MECKLENBURG COUNTY HEALTH DEPARTMENT

APPLICATION FOR PERCOLATION TEST

SITE EVALUATION

SITE INVESTIGATION REPORT
INDIVIDUAL SEPTIC TANK SYSTEM
WITH SUBSURFACE,
SOIL ABSORPTION,
EFFLUENT DISCHARGE

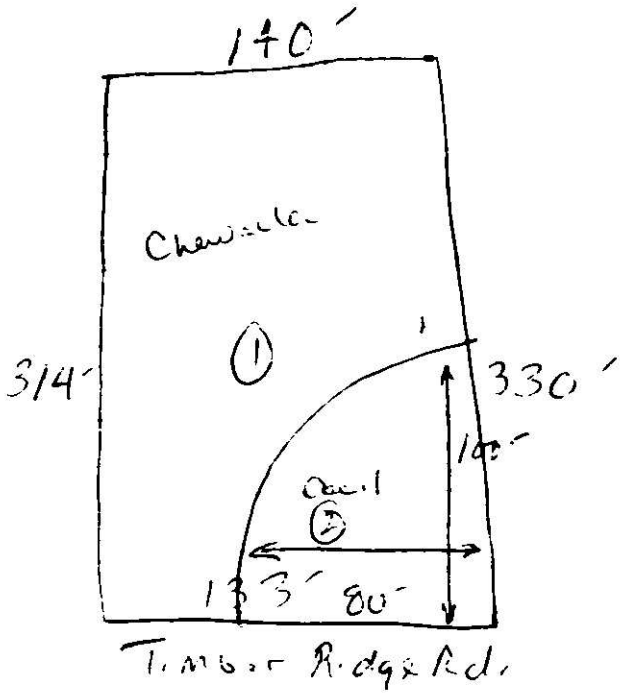
FACTORS	AREA 1	AREA 2	AREA 3	AREA 4
1. SLOPE (%)	S PS U	S PS 4-12% U	S PS U	S PS U
2. SOIL TEXTURE (12-36 in.) (Sandy, loamy, clayey, Not. .:l clay)	S PS U	S PS clay U	S PS U	S PS U
3. SOIL STRUCTURE (12-36 in.) (Clayey soils)	S PS U	S PS blocky U	S PS U	S PS U
4. SOIL DEPTH (In.)	S PS U	S PS >48" U	S PS U	S PS U
5. RESTRICTIVE HORIZONS (In.) (Impervious Strata, rock)	S PS U	S PS U	S PS U	S PS U
6. SOIL DRAINAGE/GROUNDWATER (External & Internal)	S PS U Poorly	S PS U Poor	S PS U	S PS U
7. SOIL PERMEABILITY (Percolation Rate)	S PS U	S PS Moderate U	S PS U	S PS U
8. OTHER (Specify)	S PS U Soils	S PS U	S PS U	S PS U
9. SITE CLASSIFICATION*				
SOIL SERIES	Chewacla	Cecil

Recommendations/Comments: Based on this investigation the lot does not appear to have an adequate area of provisionally suitable soils for installation of a septic tank system
